June 15, 2021

In response to your email of June 2, which was in response to our comments to Prairie Township of May 29, we wanted to ask some questions and add some points to further represent our position.

**Case No(s). 20-1679-EL-BGN**

Summary: Public Comment of Anthony Sasson, "via website". electronically filed by  
Docketing Staff on behalf of Docketing

**Figure 1** Hamilton Run and McCoy Ditch upstream of US 40, showing floodplains      **Source:** Franklin County Auditor

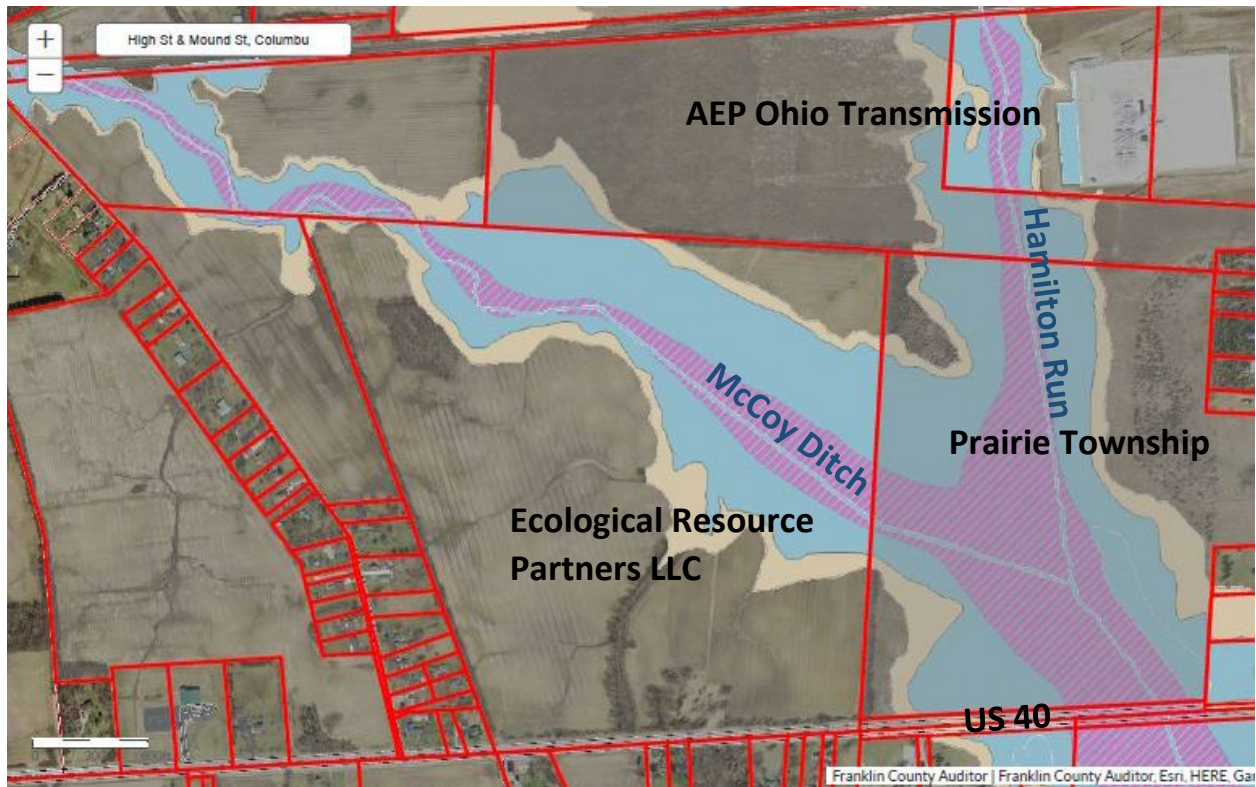
Regardless of the implementation for the ERP LLC parcel, there are two other adjacent and important parcels (see Figure 1 below) that need stream restoration along Hamilton Run and McCoy Ditch on the Prairie Township and AEP Ohio Transmission. Without active stream restoration, these two parcels likely will continue to have low-quality stream habitat and low aquatic biology scores, thereby not meeting Clean Water Act goals for Ohio's most general use designation, Warmwater

Habitat. These two streams are presently designated Modified Warmwater Habitat, Ohio's lowest-quality stream use designation.
